**SAMPLING AND ANALYSIS PLAN
AMBASSADOR LAUNDRY SITE
1160-1168 36TH STREET AND
3601 AND 3623 ADELIN STREET
EMERYVILLE, CALIFORNIA**

Subject: Response to Comments on the Review of the Sampling and Analysis Plan Ambassador Laundry Site, 1160 – 1168 36th Street and 3601 and 3623 Adeline Street, Emeryville, California (EPA QA Office DCN: BNFD0260SV1)

Response to Comments on the Sampling and Analysis Plan Ambassador Laundry Site, 1160 – 1168 36th Street and 3601 and 3623 Adeline Street, Emeryville, California

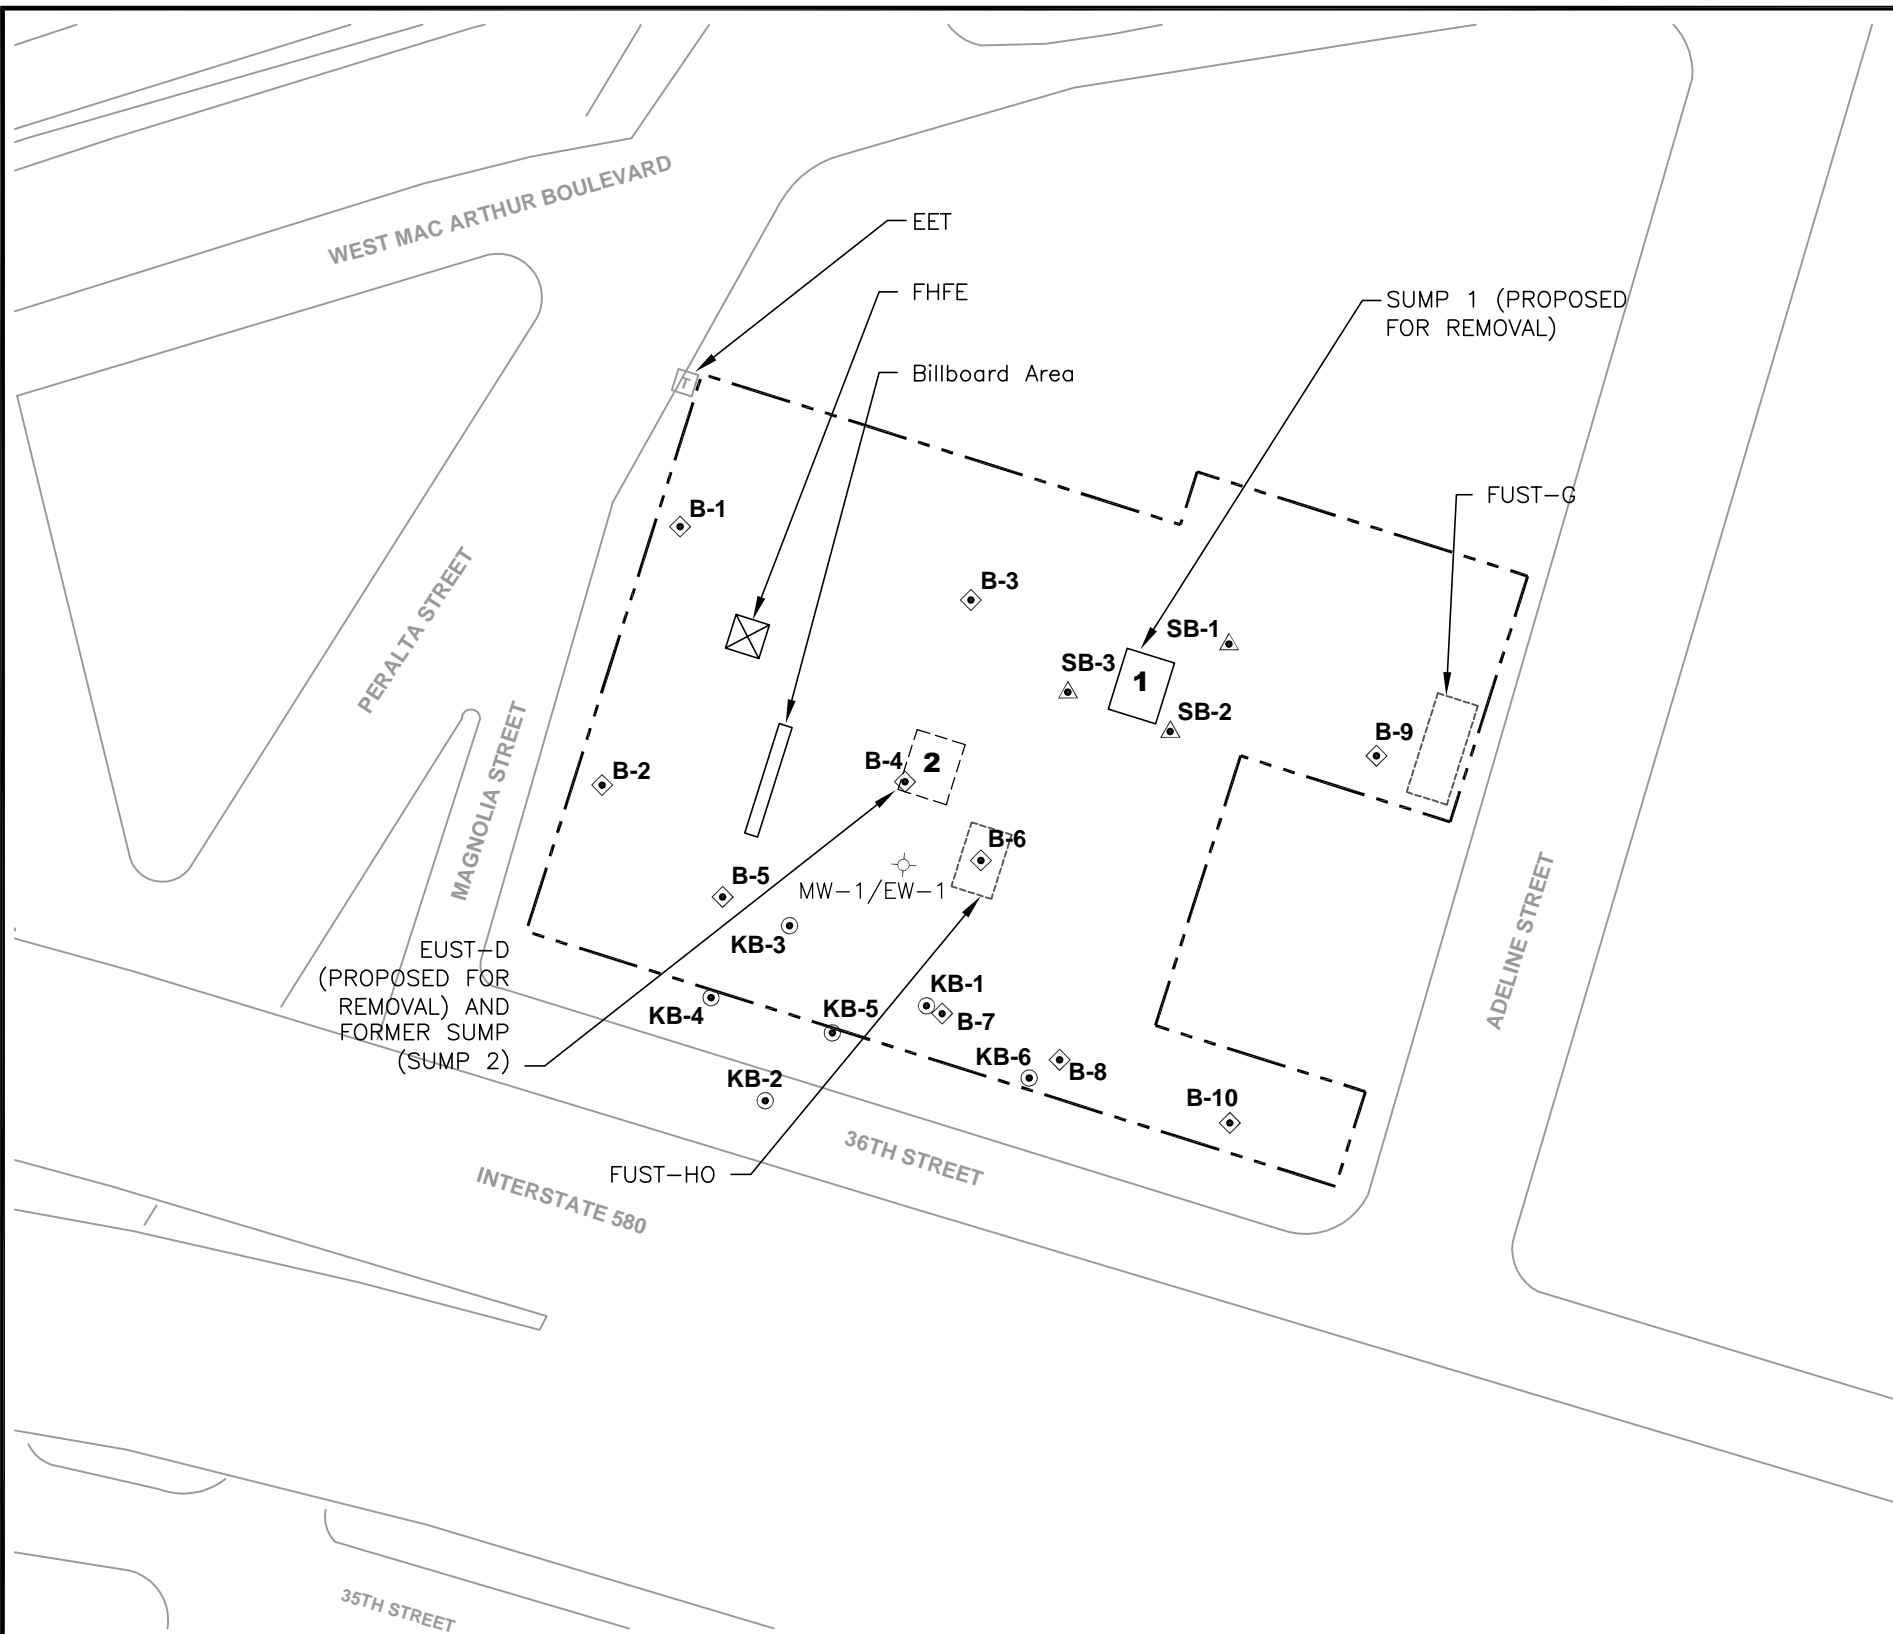
In the paragraph describing the September 21, 1999 investigation conducted by PES Environmental, Inc., it is stated that three soil borings, SB-1, SB-2, and SB-3, were placed "near a recently discovered sump." However, when Plate 3, Previous Sampling Locations, was referenced by the reviewer the closest of the clustered borings, SB-3, appears to be over 30 feet away from the single sump identified on the plate. If the sump location and boring locations are correct, then it is not clear to the reviewer how useful this data will be to the current project. If there is a second sump that has not been identified on the plate in the area where the borings had been placed it needs to be added to the plate for reference

In the paragraph describing the August 2005 structure demolition by Clayton, it was noted that “a sump containing oily sludge was discovered.” Per the paragraph, the sump was removed. Is this a third sump? If so, it needs to be added to the plate for reference purposes. The existence of a third sump at the site may impact the current project DQOs.

The last paragraph of this section describes 10 soil borings that were advanced in May 2003 by Clayton. Approximately 10 soil borings appear to be referenced on Plate 3, Previous Sampling Locations. However, according to the key provided for Plate 3, those soil borings were advanced by Kleinfelder in 1996 and PES Environmental in 1999. It is not clear to the reviewer if there are an additional 10 borings by Clayton that need to be

added to the plate or if the borings currently represented are misidentified. This paragraph and the plate need to be reviewed and revised for consistency. (Also see Comment 25B)

Kleinfelder has reviewed available information and has edited Plate 3 to clearly identify the location of the two sumps. One of them, now labeled as Sump-1 in Plate 3, was discovered and cleaned by PES in 1999. The other sump (Sump 2) was discovered and removed by Clayton in 2005.

Kleinfelder clarified in Section 2.3 that only two sumps have been discovered at the Site: one in 1999 by PES (Sump-1), and the other in 2005 by Clayton (Sump-2). The summary of the PES report suggests that Sump-1 was cleaned and left in place. Clayton’s 2005 report indicates that Sump-2 was removed. The approximate location of the existing Sump (Sump 1) and the former sump (Sump 2) are presented in Plate 3.

Kleinfelder has reviewed and corrected both the text on Section 2.3.2 and Plate 3.

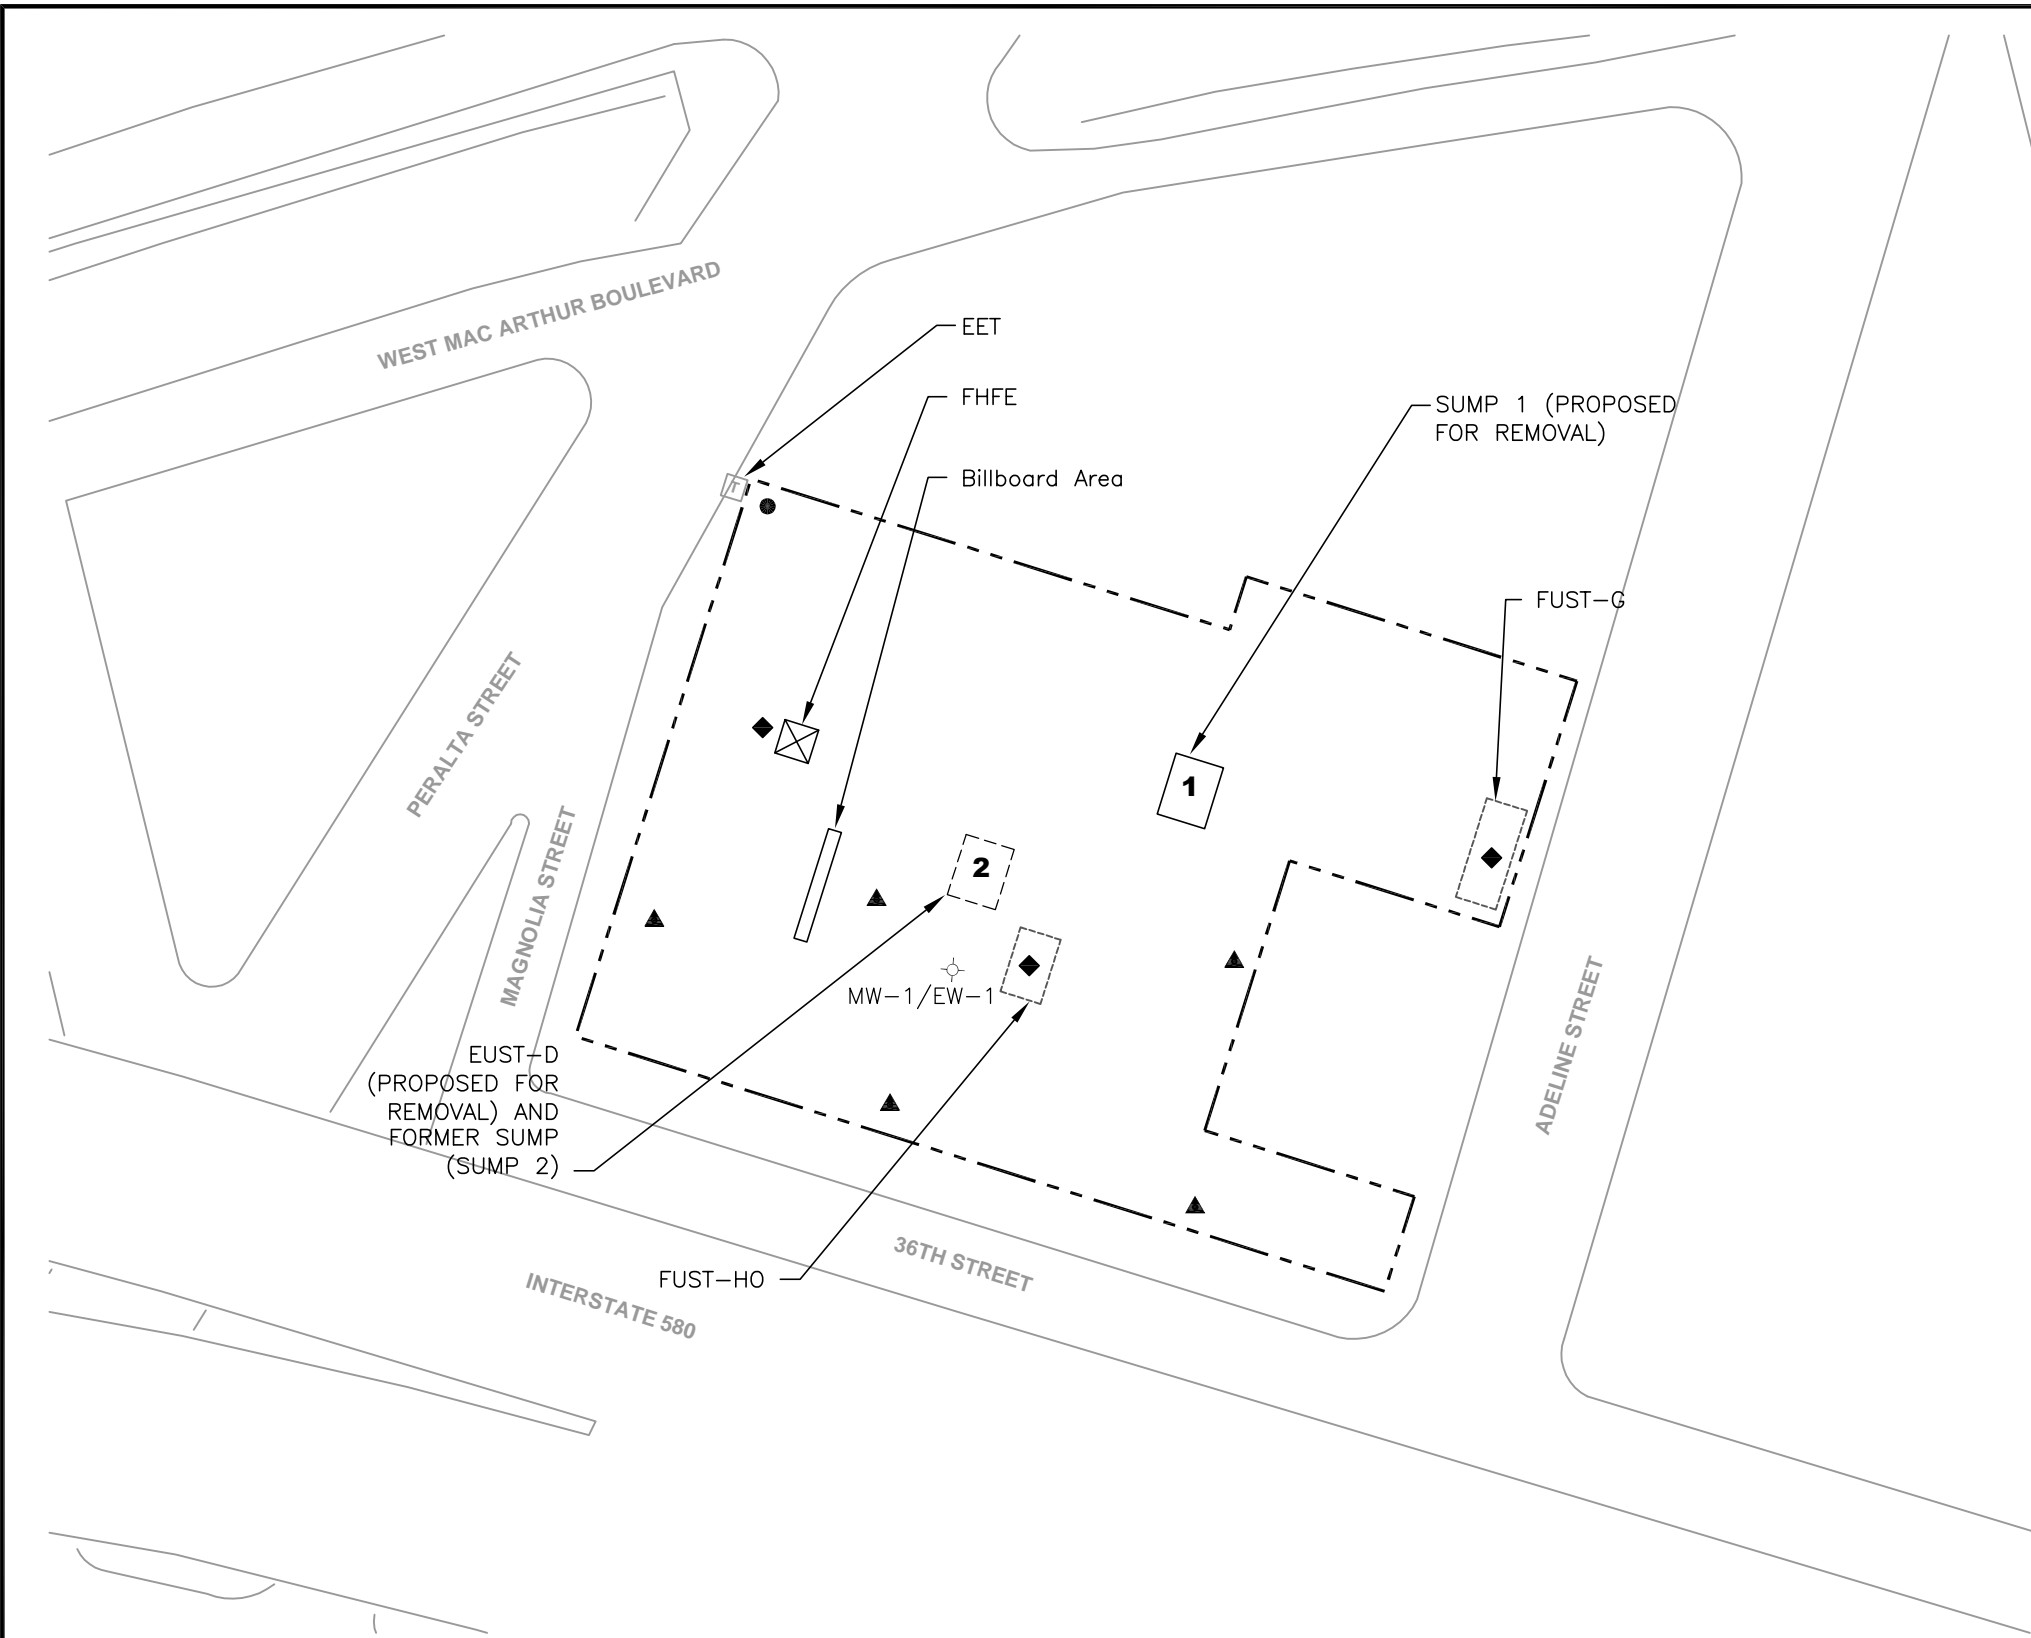
<p>Comment 14A [Section 4.4.1, Soil Vapor; Plate 4, Proposed Sampling Locations] It is noted that a subcontractor will provide onsite mobile laboratory analysis of the soil vapor samples. If known, the subcontractor should be identified in the SAP.</p>	<p>Kleinfelder intends to retain the services of Trans-global Environmental Geochemistry (TEG) of northern California to perform soil vapor sampling and analysis; this information has been included in Section 4.4.1 of the SAP.</p>
<p>Comment 14B The rationale for collecting the two northern most soil vapor samples is not clear to the reviewer. The positioning of the other soil vapor samples is understood to be down gradient, south/south-west of former USTs. Clarification should be provided.</p>	<p>The purpose of collecting the proposed most north-western sample was for obtaining additional characterization of the Site; however, since no indication that petroleum hydrocarbons were handled or stored in this area, Kleinfelder has removed the proposed two northern most soil vapor sampling locations.</p>

The summary table of proposed sampling and analyses provided in this section incorrectly references Plate 3, Previous Sampling Locations. It should reference Plate 4, Proposed Sampling Locations. The table should be corrected.

The table indicates that seven soil vapor samples are to be collected. However, Plate 4 shows eight soil vapor sampling locations. The number of sampling locations for the soil vapor portion of the project should be reviewed and made consistent in this section and throughout the SAP.

<p>Comment 19 [Section 6.3.2, Soil Vapor Sampling] This section incorrectly cross-references Plate 3. The relevant information is actually on Plate 4. The reference should be revised.</p>	<p>Kleinfelder referenced Plate 4 in Section 6.3.4 (former Section 6.3.2).</p>
<p>Comment 20 [Section 7.1.1, UST Excavation Confirmation Samples] It is stated that metals have a hold time of six months. This is consistent with EPA's currently recommended hold times for all metals, except mercury. EPA's recommended hold time for mercury analysis is 28 days for soils. This</p>	<p>Kleinfelder added the correct holding time for mercury analysis to Section 7.1.1.</p>

The summary table of proposed sampling and analyses originally provided in Section 4.4.3 has been removed. Instead, Table 2 presents the Soil Vapor, Soil, and Groundwater Sampling Design for this investigation. The areas of concern and the numbers of proposed samples listed in Table 2 are also referenced on Plate 4, Proposed Sampling Locations.

The number of locations for the soil vapor portion of the project (five soil vapor locations) was reviewed and is consistent throughout the SAP.
